Form 3160-5  
(June 2019)UNITED STATES  
DEPARTMENT OF THE INTERIOR  
BUREAU OF LAND MANAGEMENTFORM APPROVED  
OMB No. 1004-0137  
Expires: October 31, 2021**SUNDRY NOTICES AND REPORTS ON WELLS**  
**Do not use this form for proposals to drill or to re-enter an abandoned well. Use Form 3160-3 (APD) for such proposals.**

8. Well Name and No. RUTHLESS 11 FED COM/707H

EOG respectfully requests an amendment to our approved APD for this well to reflect the following changes:

#### Revised Permit Information 03/04/2022:

## WELL LOCATION AND ACREAGE DEDICATION PLAT

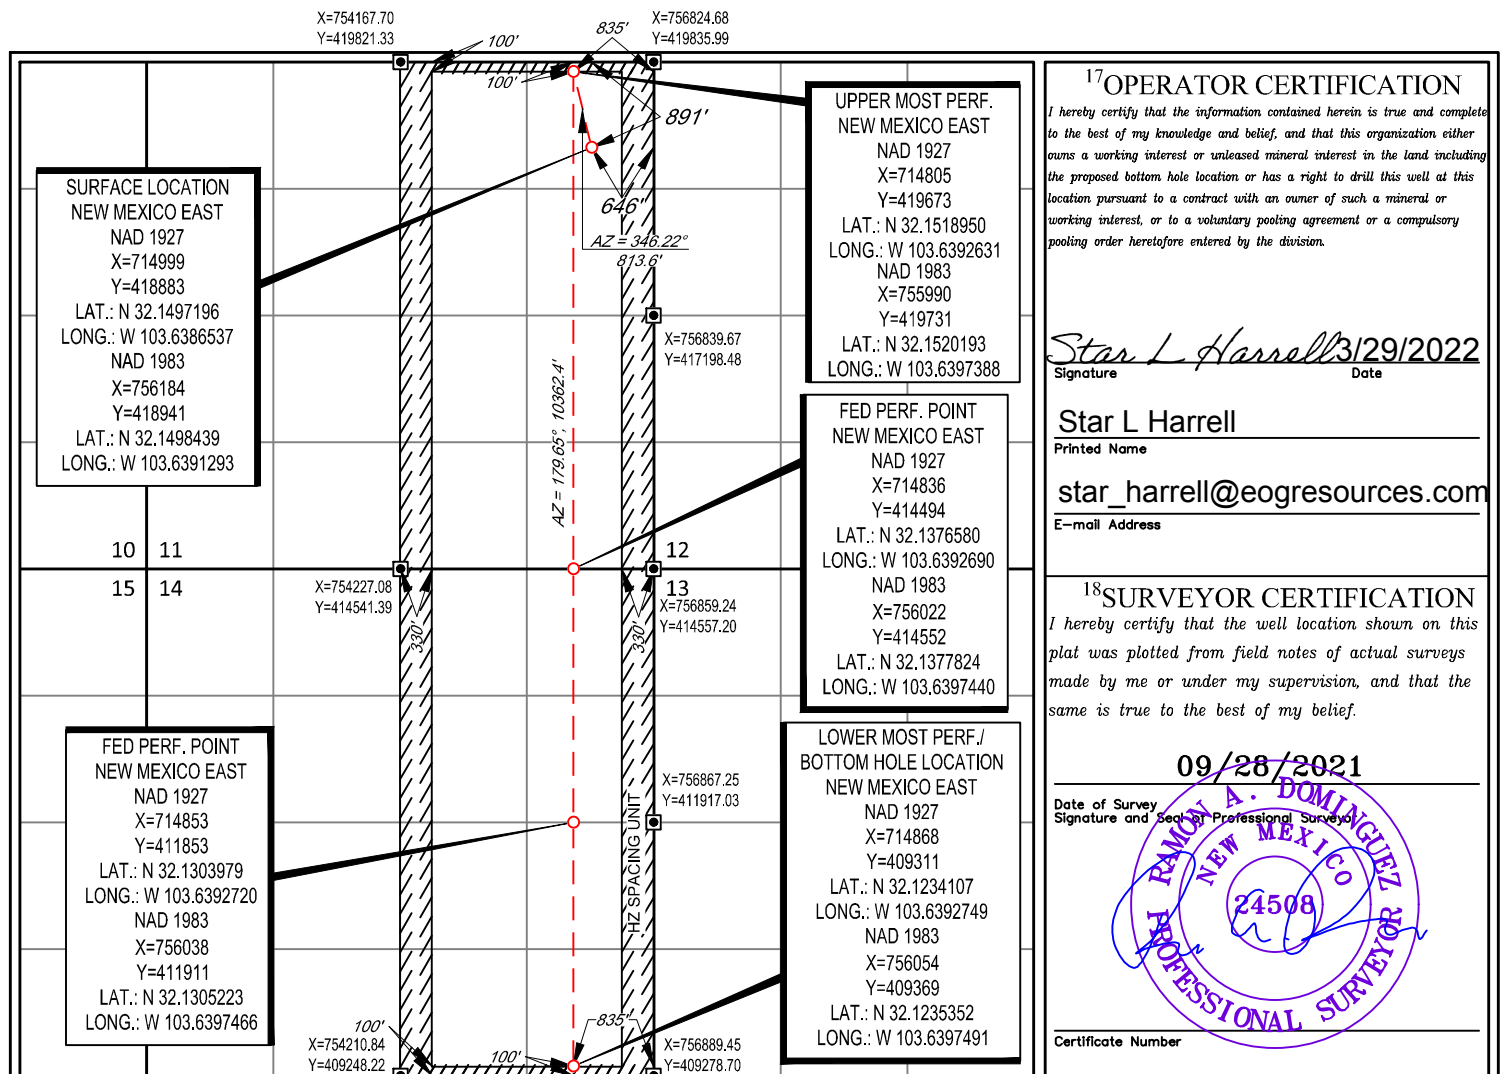
Change BHL from T-25-S, R-32-E, Sec 14, 100' FSL, 990' FEL, Lea Co., NM,  
to T-25-S, R-32-E, Sec 14, 100' FSL, 835' FEL, Lea Co., N.M.

UL or lot no.	Section	Township	Range	Lot Idn	Feet from the	North/South line	Feet from the	East/West line	County
<b>P</b>	<b>14</b>	<b>25-S</b>	<b>32-E</b>	<b>-</b>	<b>100'</b>	<b>SOUTH</b>	<b>835'</b>	<b>EAST</b>	<b>LEA</b>

Proposed Wellbore

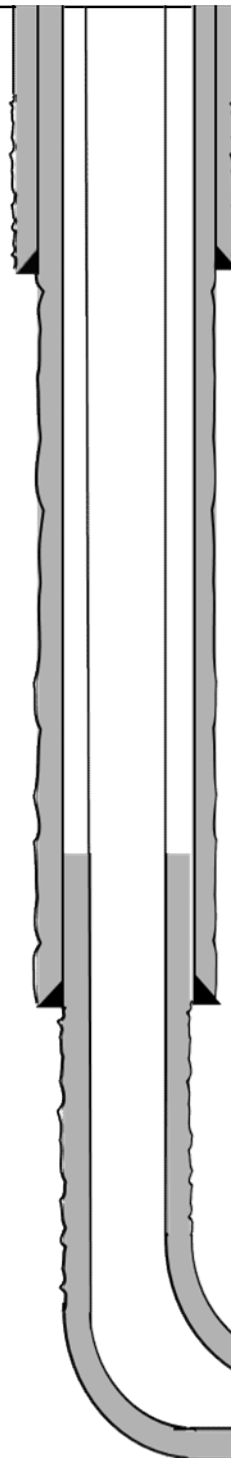
Update casing and cement program to current design.

**Bit Size: 13"**  
10-3/4", 40.5#, J-55, STC,  
@ 0' - 940'

**Bit Size: 9-7/8"**  
8-3/4" 38.5#, P110-EC, Vam Sprint-SF,  
@ 0' - 11,100'

**Bit Size: 7-7/8"**  
6", 24#, P110-HP, Eagle SFH SC,  
@ 0' - 22,598'
